## **PLAN REVIEW SHEET**

**Telephone:** 704-353-0018 **Petition:** 2016-092

Charlotte-Mecklenburg Housing Partnership

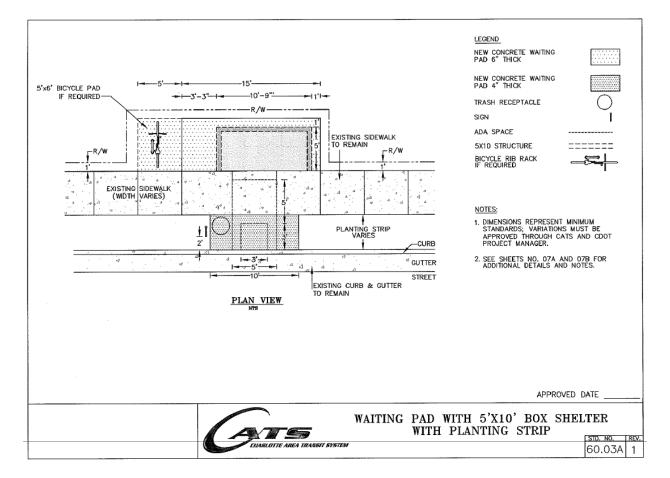
This site is located on two planned new bus routes connecting to Uptown via Statesville Road, as well as to Rosa Parks Community Transit Center via Cindy Lane. The Petitioner is requested to provide and construct two bus shelter pads, one each on Statesville Road, and one on Cindy Lane.

Below is an image of the standard detail (60.03A) for the requested bus shelter pads, one each on Statesville Road and Cindy Lane. Permanent easement is requested, where dimensions exceed existing or proposed right-of-way limits.
